**VOLLMER ROAD  
STA 10+00.00 TO STA 24+00.00**

BY	DATE	No.	REVISION	H-SCALE	V-SCALE	DATE	DESIGNED BY	DRAWN BY	CHECKED BY
				1"=50'	1"=5'	05/13/21	RAB	KRW	
STERLING RANCH - VOLLMER ROAD FILING 2 PLAN & PROFILE									
SHEET 3 OF 11									
JOB NO. 25188.01

STERLING RANCH -  
 VOLLMER ROAD FILING 2  
 SIGNAGE & STRIPING

**VOLLMER ROAD**  
 STA 23+50.00 TO STA 39+00.00

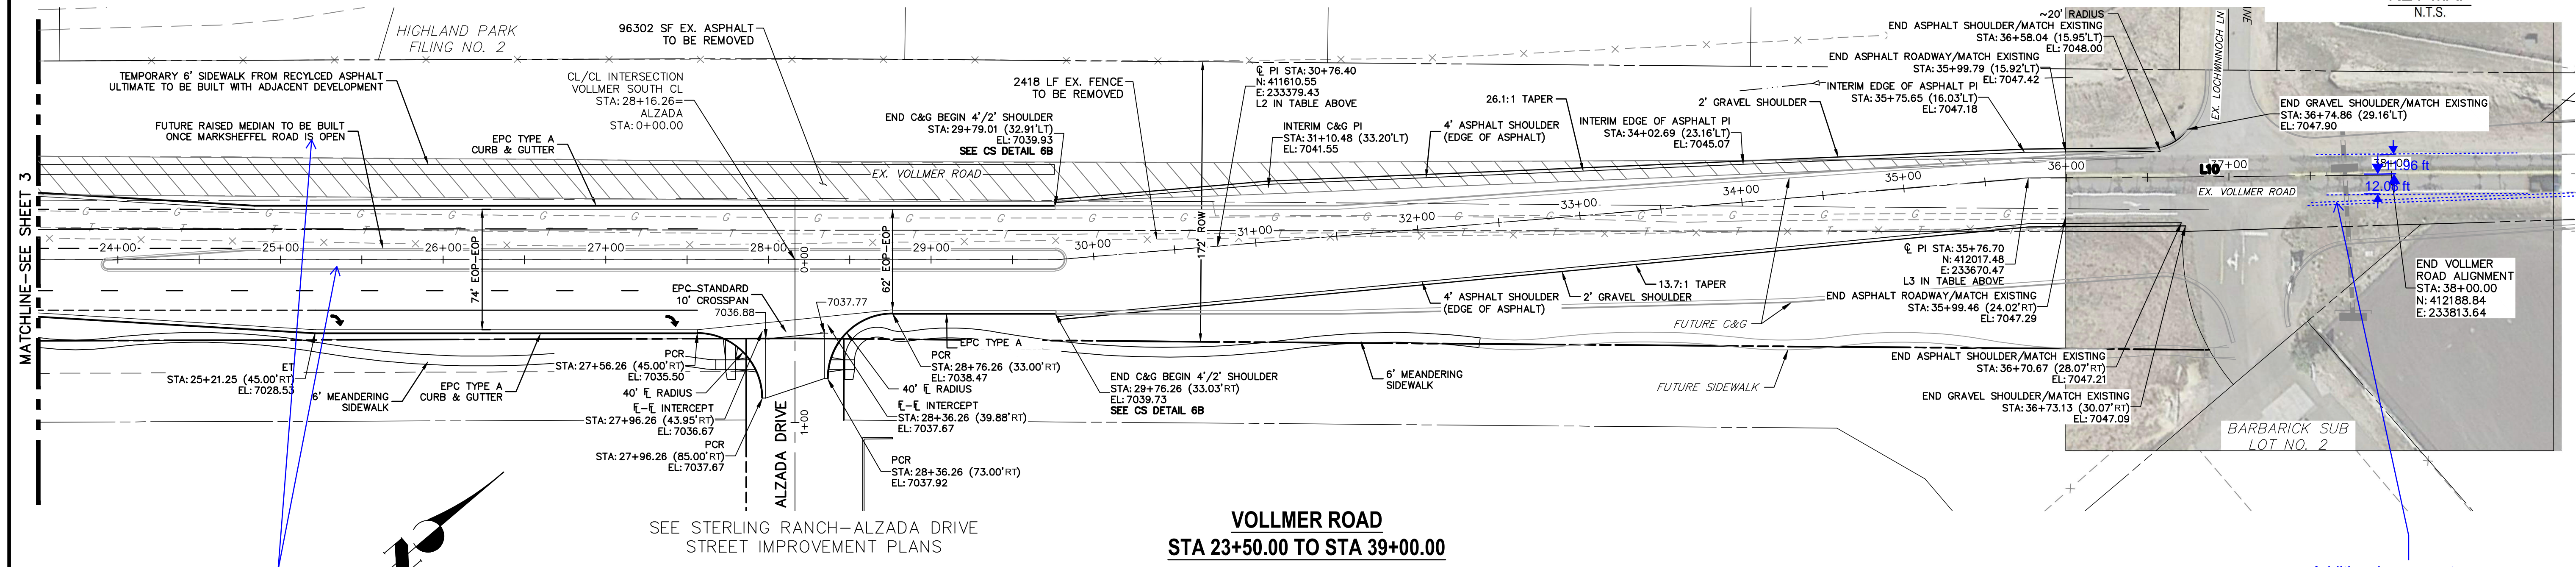
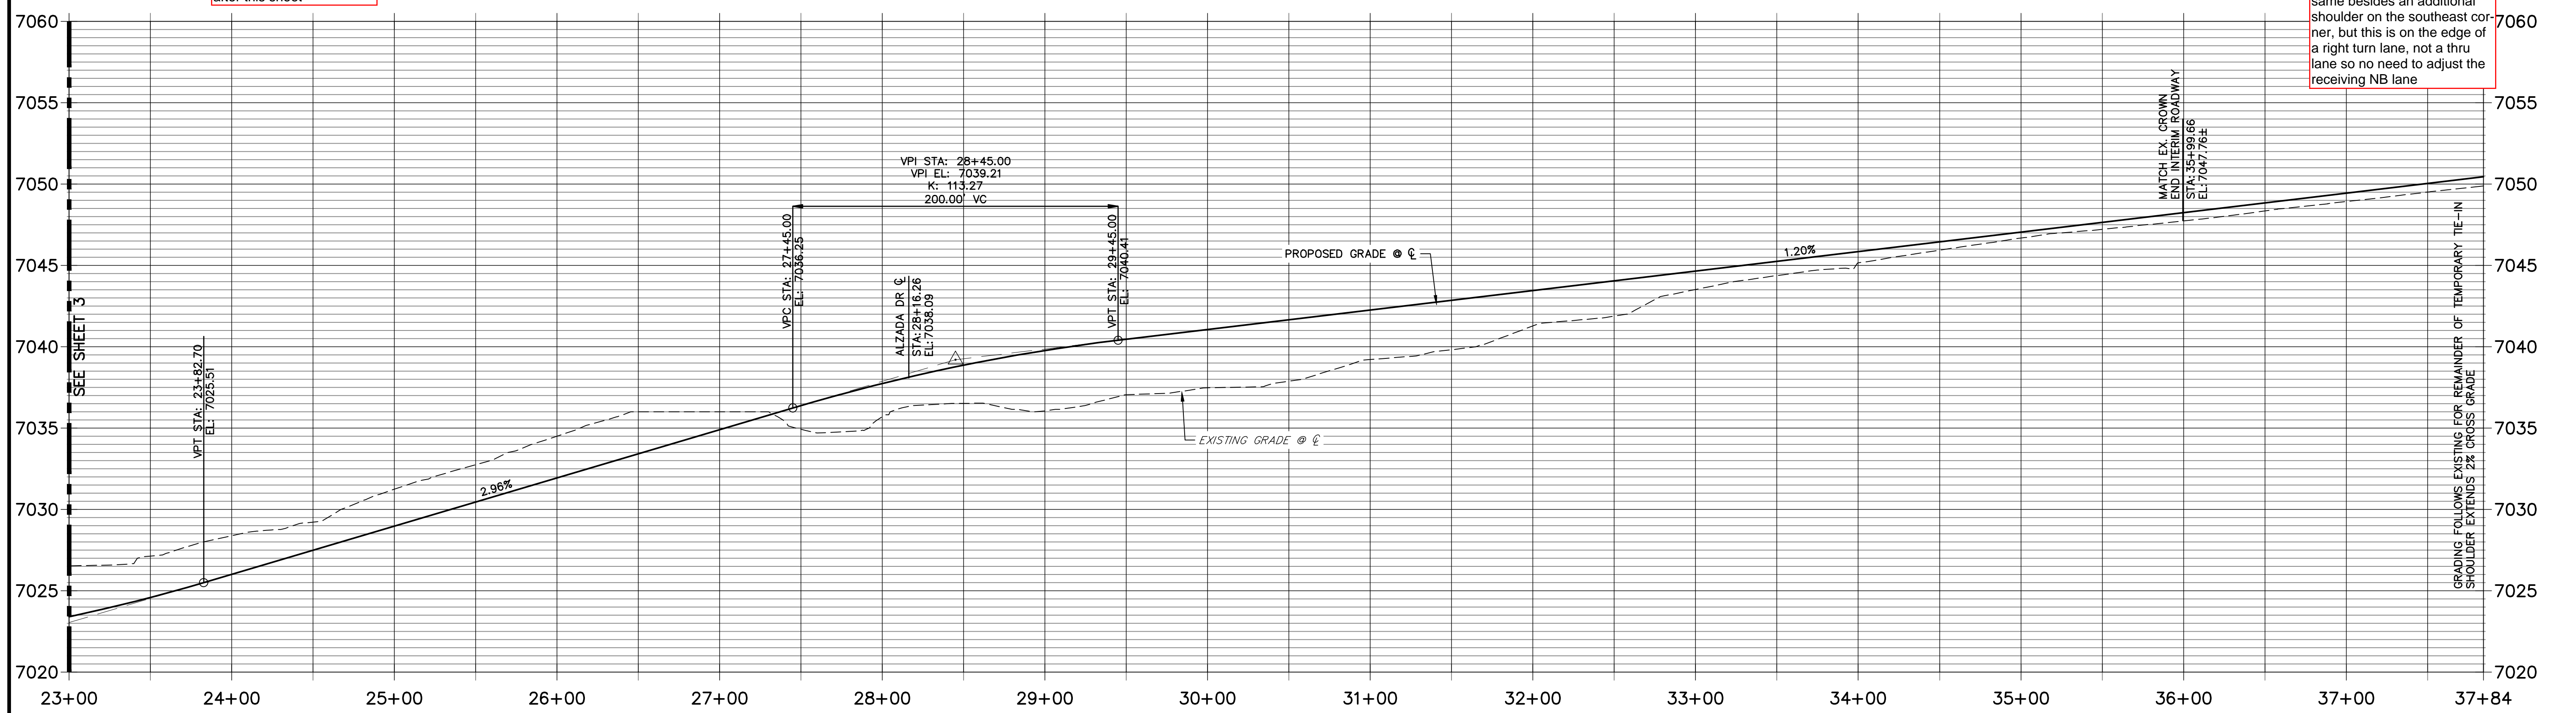
provide plan and profile sheet

Median detail sheet added after this sheet

Additional pavement shoulder taper required to align with lane from south?

No-existing lane geometry of the intersection remains the same besides an additional shoulder on the southeast corner, but this is on the edge of a right turn lane, not a thru lane so no need to adjust the receiving NB lane

**VOLLMER ROAD TEMPORARY CONDITION  
(VALID UNTIL MARKSHEFFEL ROAD IS OPENED)**

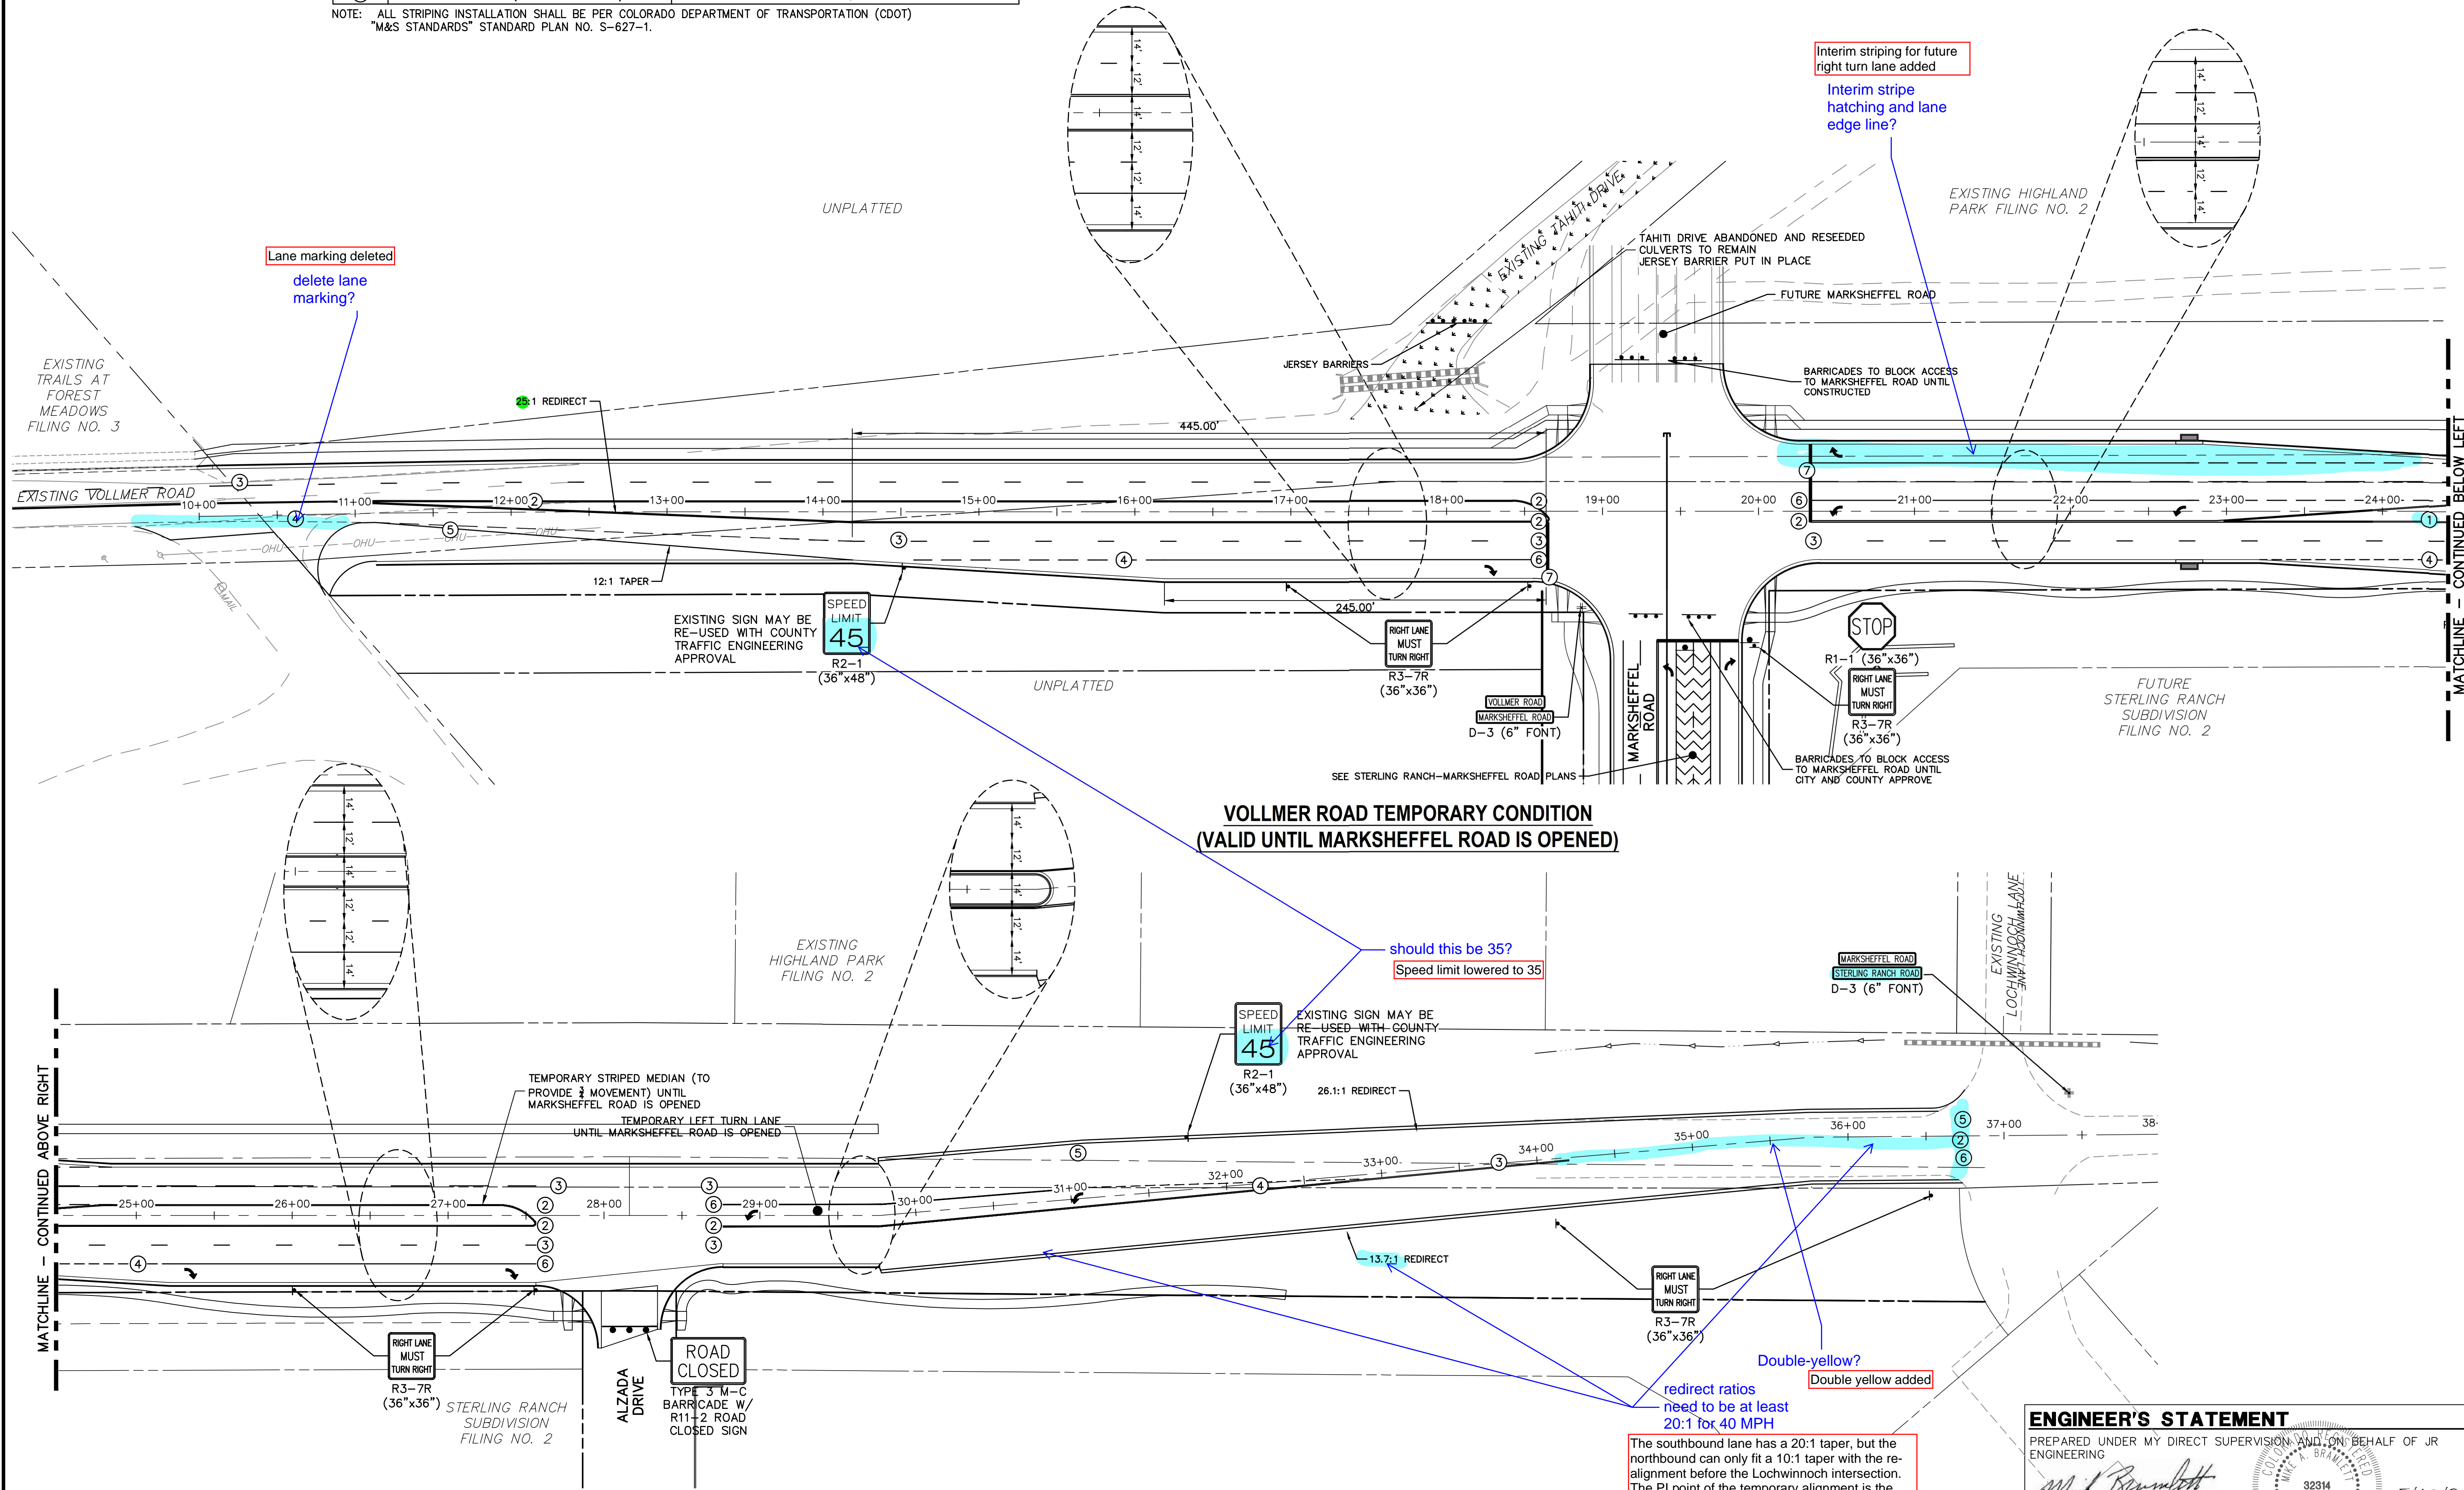
should this be 35?  
Speed limit lowered to 35

Double-yellow?  
Double yellow added

redirect ratios need to be at least 20:1 for 40 MPH

The southbound lane has a 20:1 taper, but the northbound can only fit a 10:1 taper with the realignment before the Lochwinnoch intersection. The PI point of the temporary alignment is the same as the ultimate (around Sta. 30+00) so the taper is the largest it can be without further changing the ultimate alignment (which has a 20:1 ultimate taper)
